# BID Addendum No. 4

March 19, 2021  
Bedford Fire Headquarters  
550 Old Post Road  
Bedford, NY 10506

***Note:** This addendum forms a part of the Contract Documents for the above project and modifies it with amendments and additions noted below.*

**S1.0**

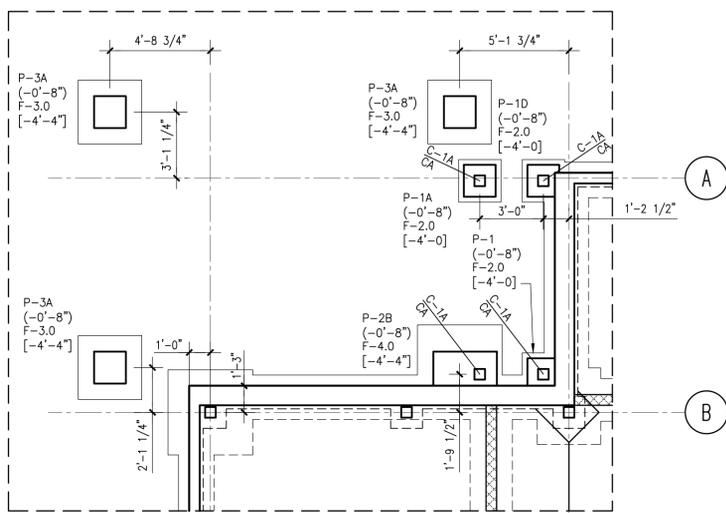
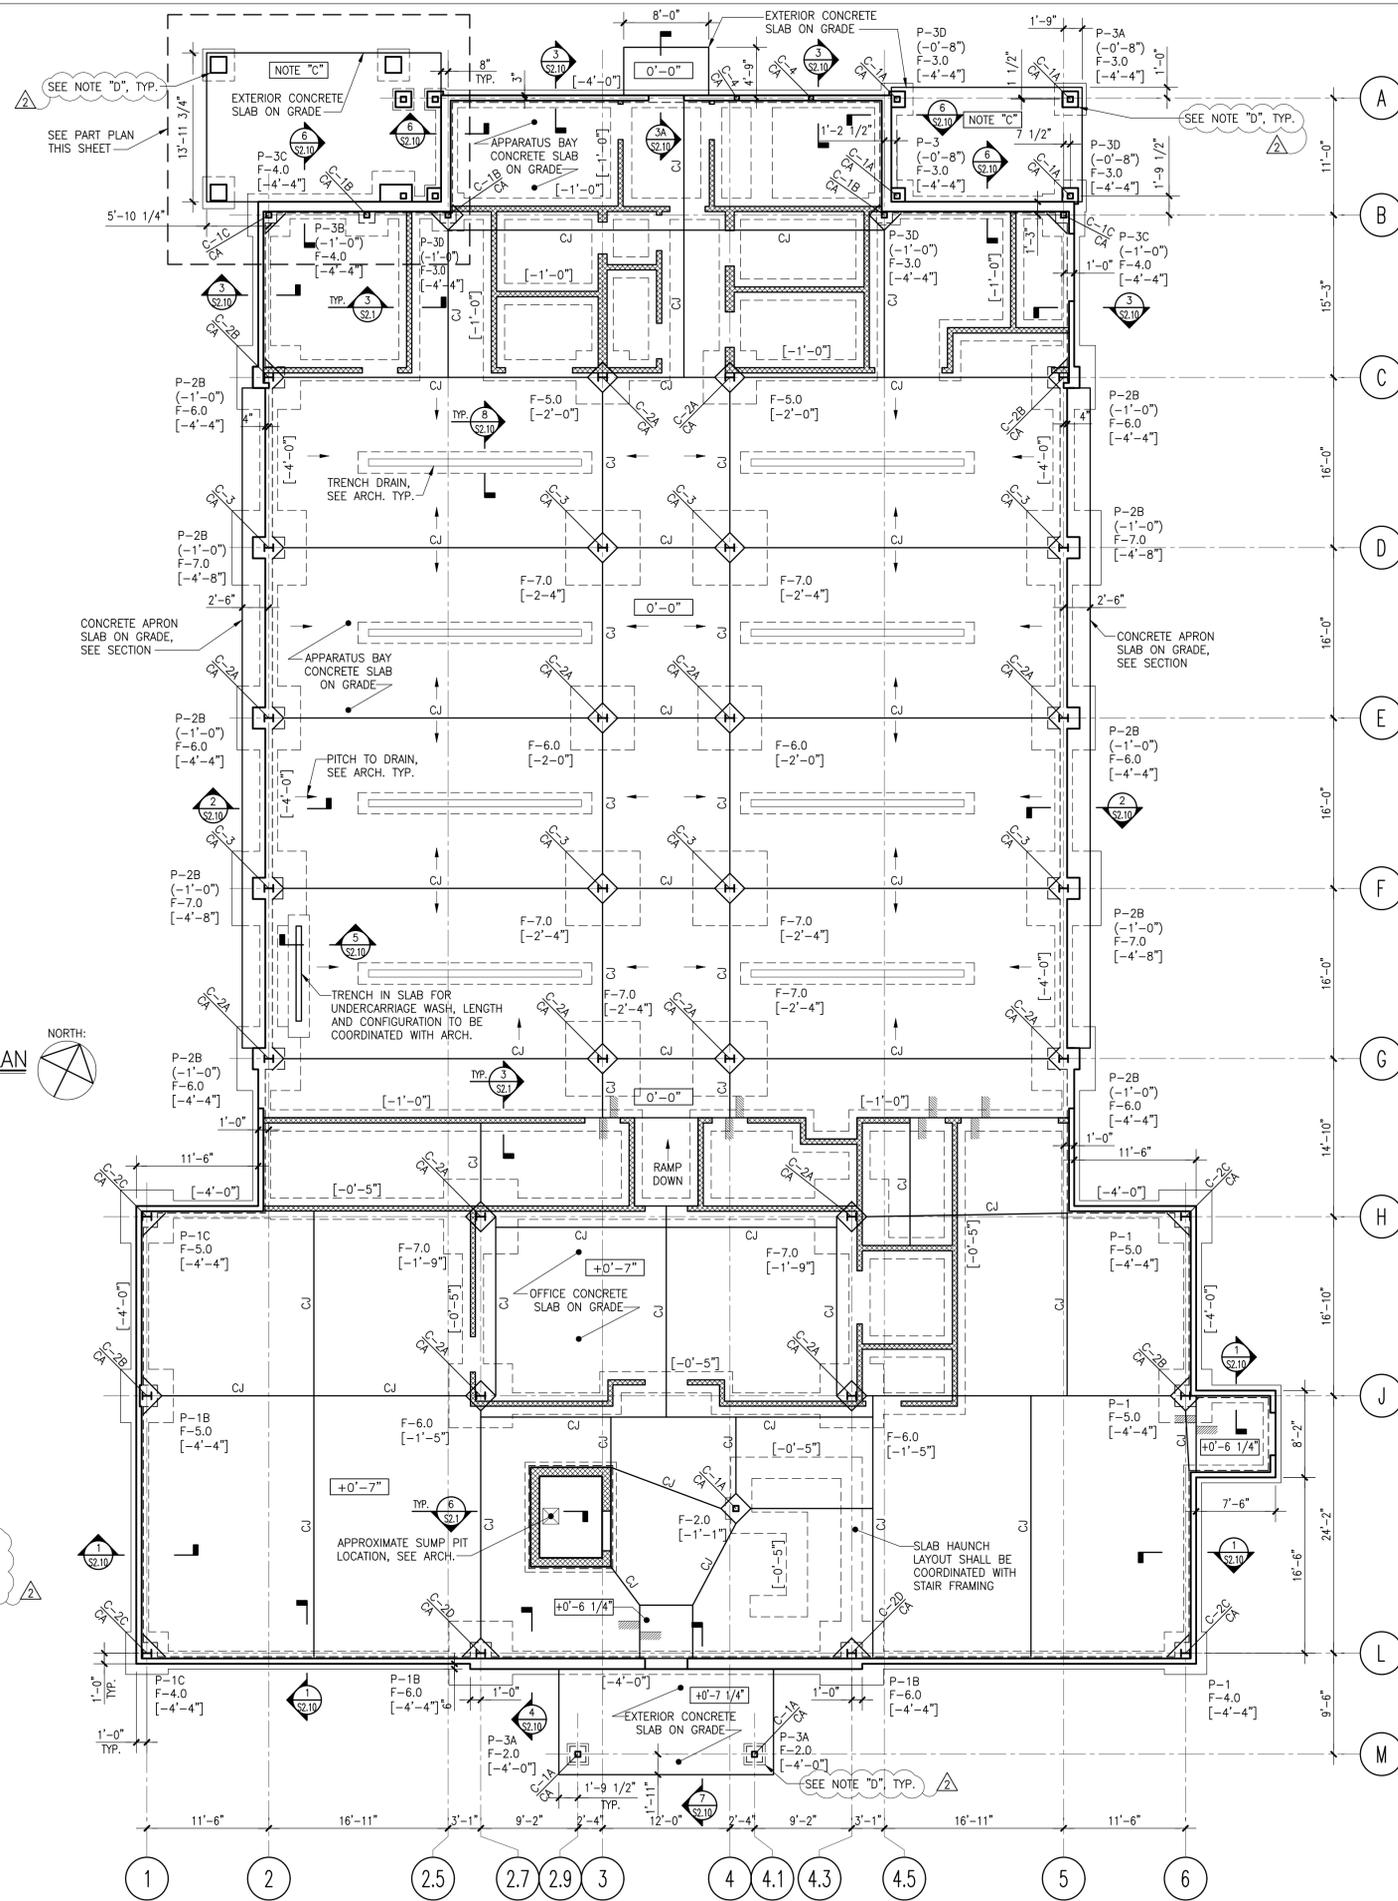
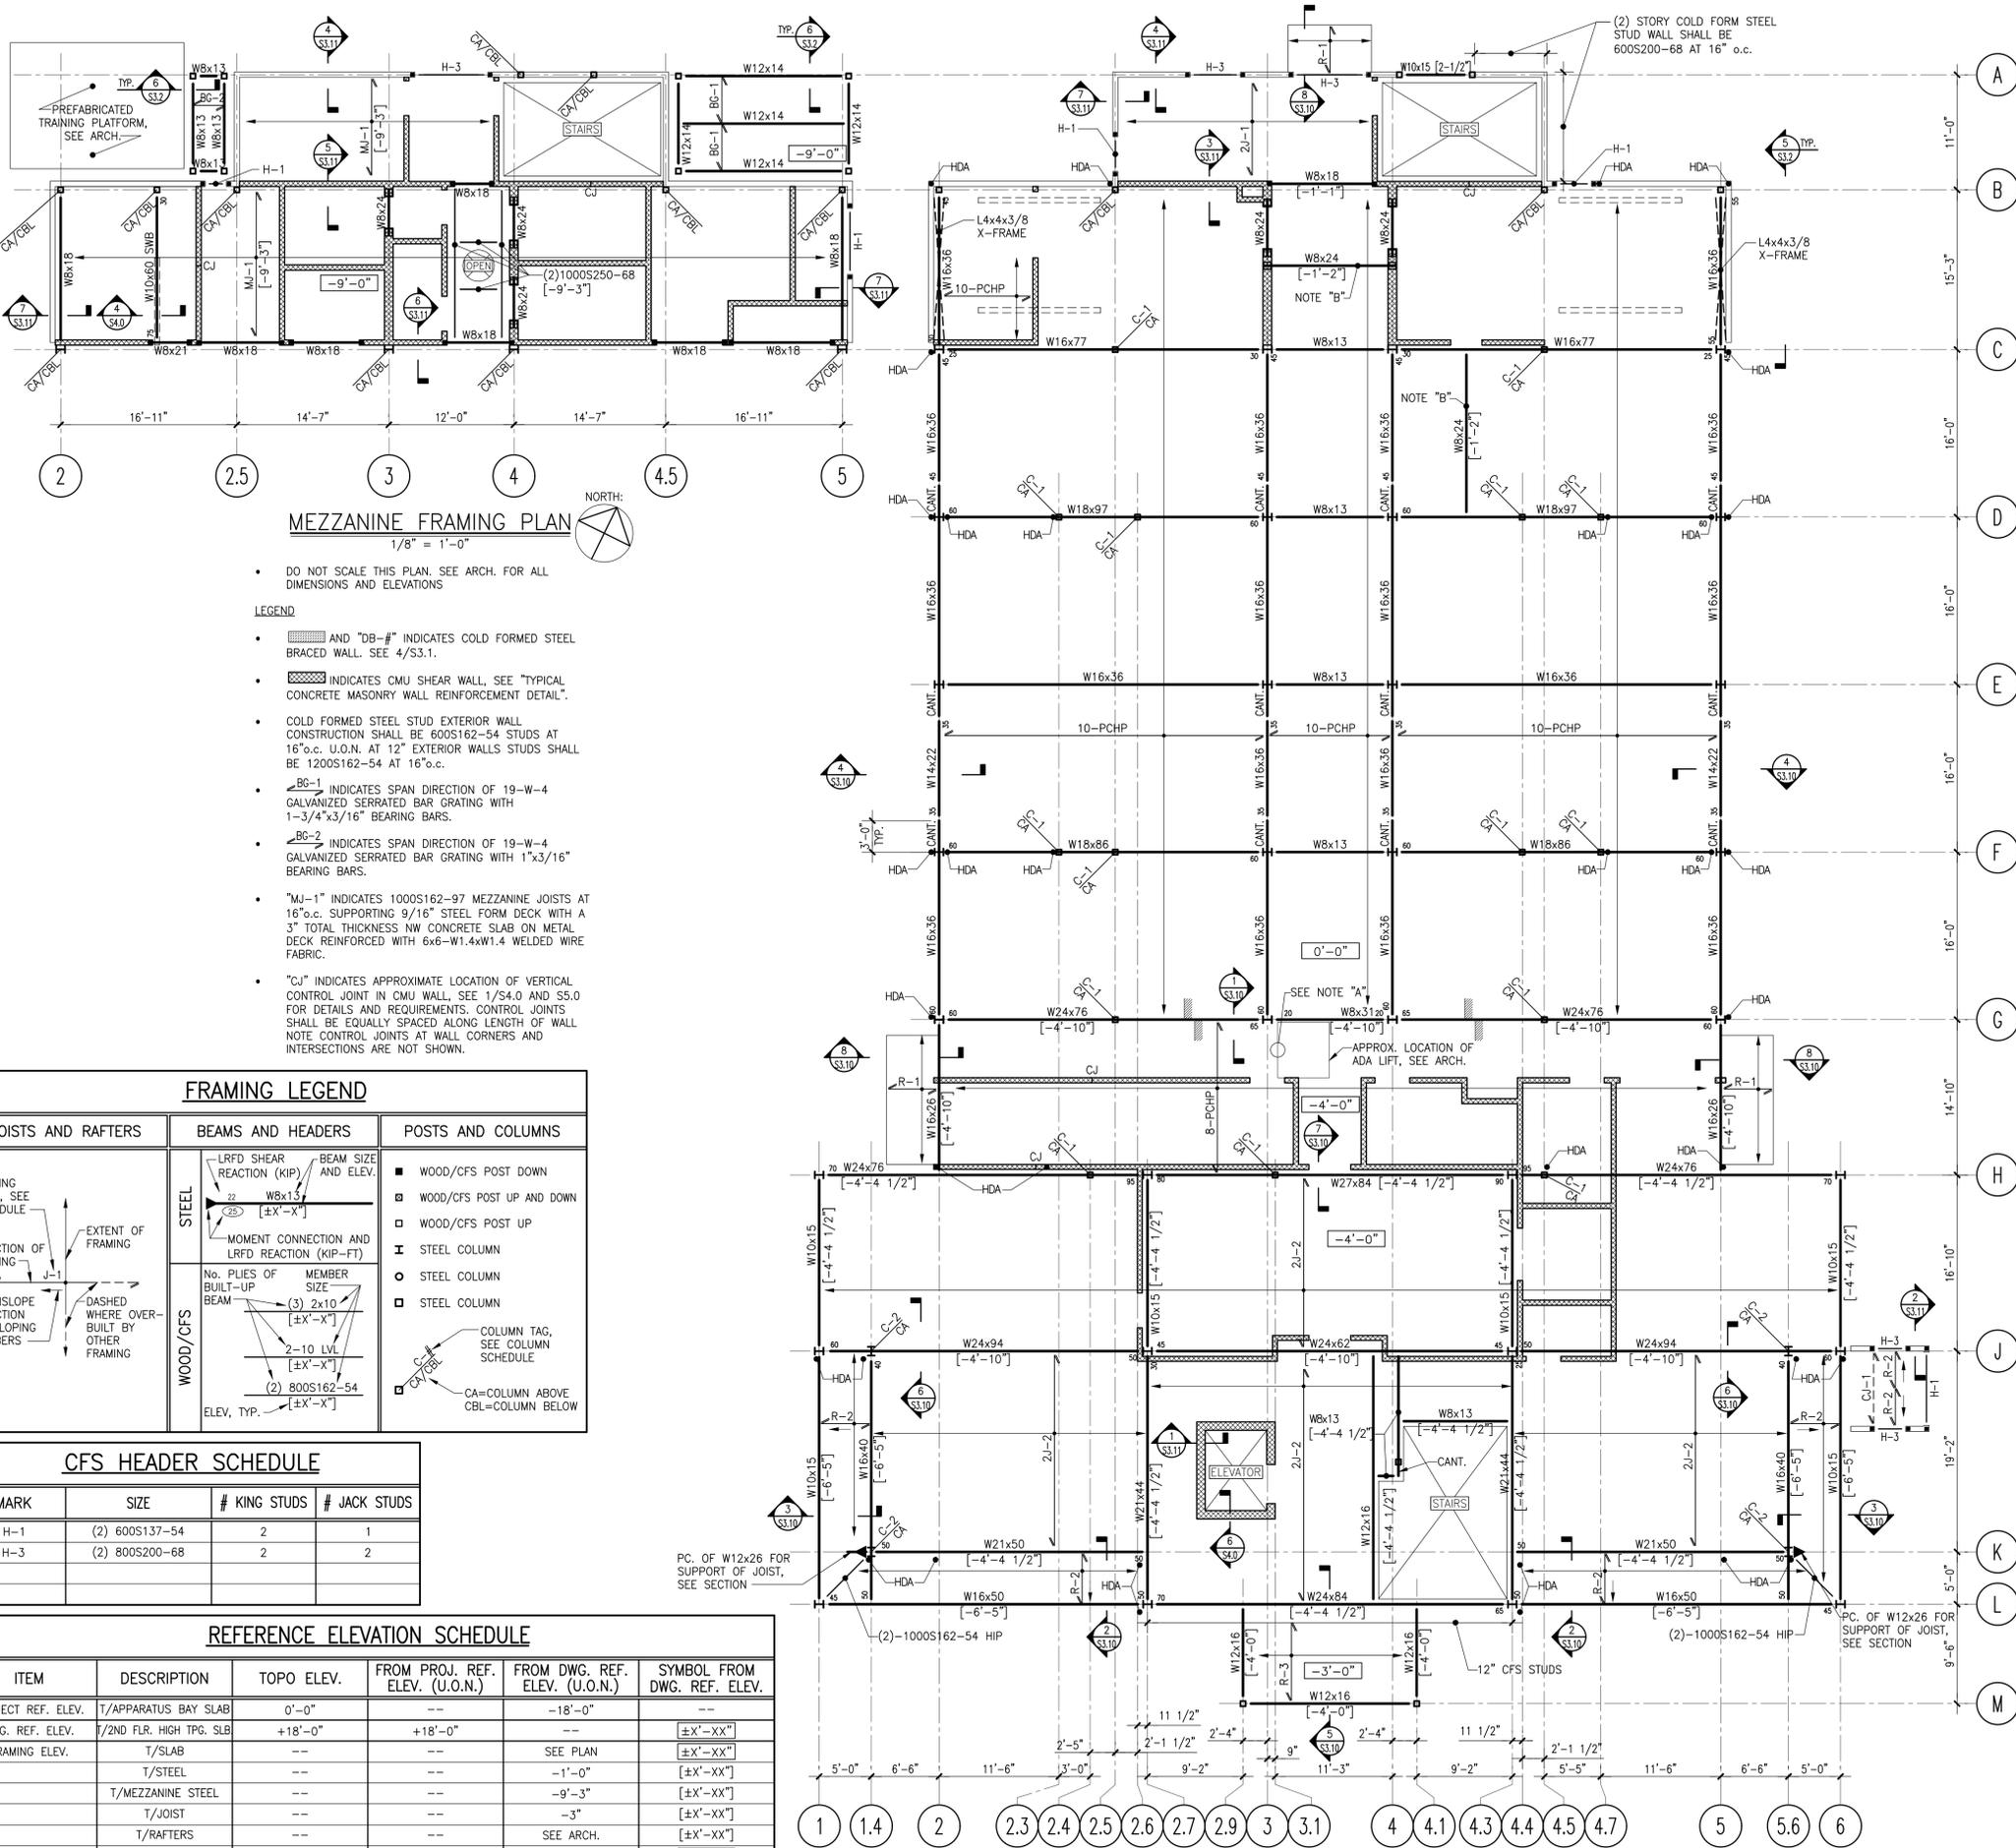
3. Drawing S1.0- Delete drawing S1.0 in set and replace with the attached revised Drawing S1.0.
4. Drawing S1.1- Delete drawing S1.1 from Addenda # 3 and replace with the attached revised Drawing S1.1.
